## 24-28 Warner Street

## Design Statement Supplement

Section 73 application.

Minor material amendment as a variation of  
condition 14 of planning permission 2011/5129/P

**Bridge Link (Privacy)**

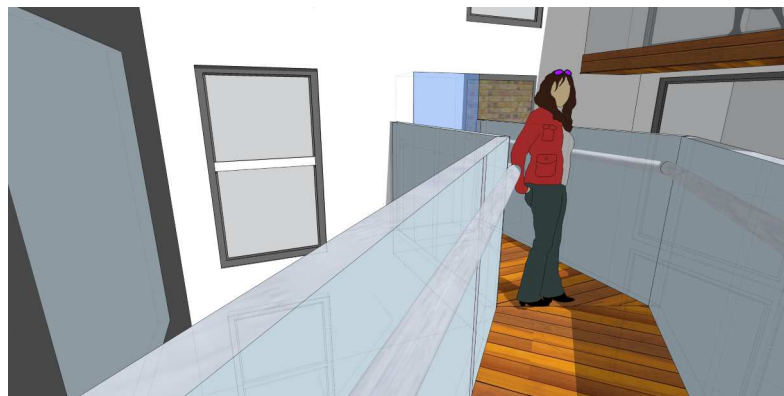
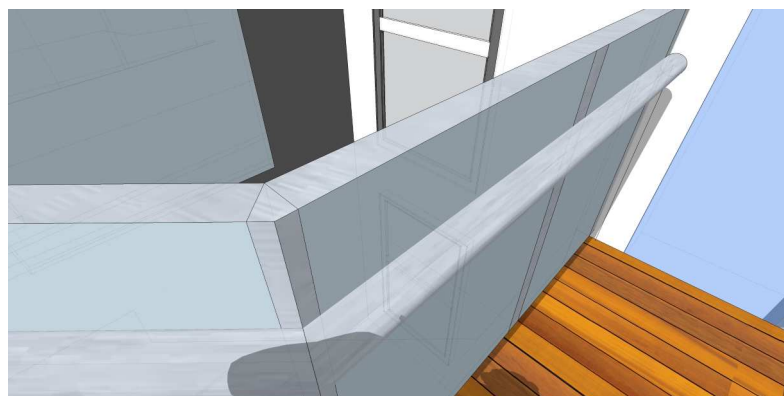
Below are a selection of diagrammatic images used to investigate the potential overlooking issues to the second bedroom of Unit 2 caused by the removal of the protective planting at ground floor level. From the key images it can be seen that a 1.350m high balustrade bridge link with obscured glass, and stainless steel handrail at 1.100, prevents views into the bedroom window.

This has been investigated fully, resulting in the bridge links Balustrade being increased to 1.350m with opaque glass sides to provide an improved solution to the consented scheme. Cf next section for supporting info.

Submitted proposed layout

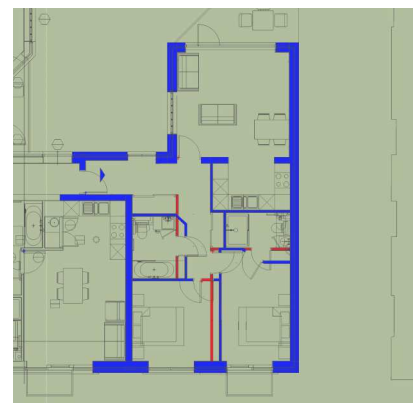
Adaptions: New stud locations in Green

Adaptions: Removed studs in red
